• TOWN PARKING LOT NUMBER 2 CONCEPT

SUGGESTED REVISIONS: TOWN PARKING LOT NUMBER 2 CONCEPT*

Illustration of raised walkway on Rosemary Street (Seen from vantage point "D")

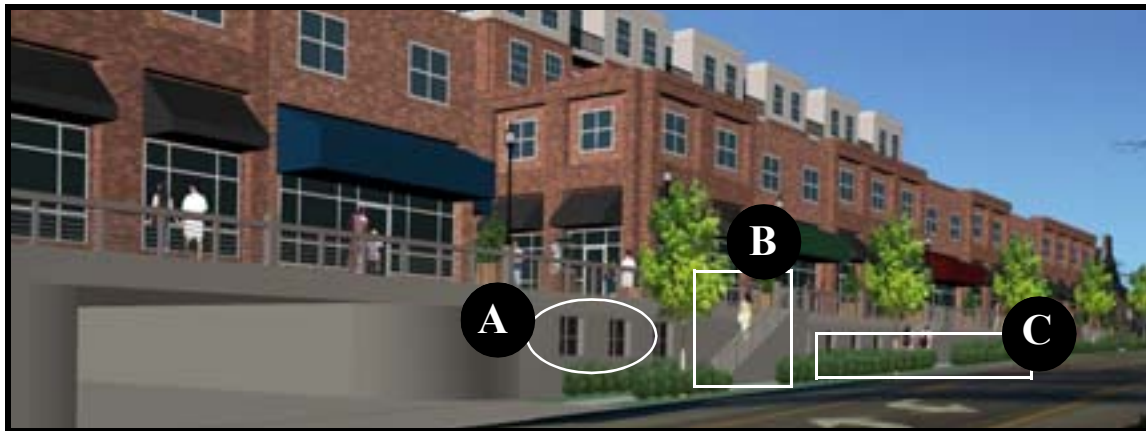
2. Updated illustration with changes suggested on March 23: A) add window openings to soften garage facade; B) add stairway providing additional access to existing sidewalk from elevated walkway; C) add landscaping to street side of Rosemary Street sidewalk.
